Bulletin

TIMKEN

Part Number: HA599467

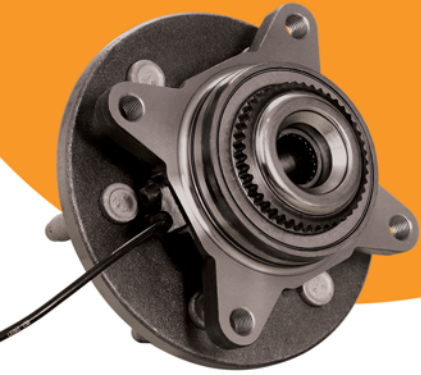
Part Number HA599467 had been listed in our catalog as the hub part number for both the 4X2 Non-ABS and the 4x4 Non-ABS 2002-2005 Jeep Liberty. It was recently brought to our attention that this part is only applicable for the 4x4 vehicles, not the 4x2 vehicles. We are making this hub part number obsolete. We are launching two new numbers for the 2002-2005 Jeep Liberty: HA590458 for the 4x4 Non-ABS and HA590452 for the 4x2 Non-ABS.

Non-Formed Hub Unit assembly is only suitable for 4X4 vehicle applications. It must not be used in 4X2 applications. If fitted to a 4X2 vehicle the vehicle's wheel will not be secure and will come off, creating a risk of death or serious injury.

HA590458 – 2002-2005 4X4 Non-ABS Jeep Liberty

HA590452 – 2002-2005 4X2 Non-ABS Jeep Liberty
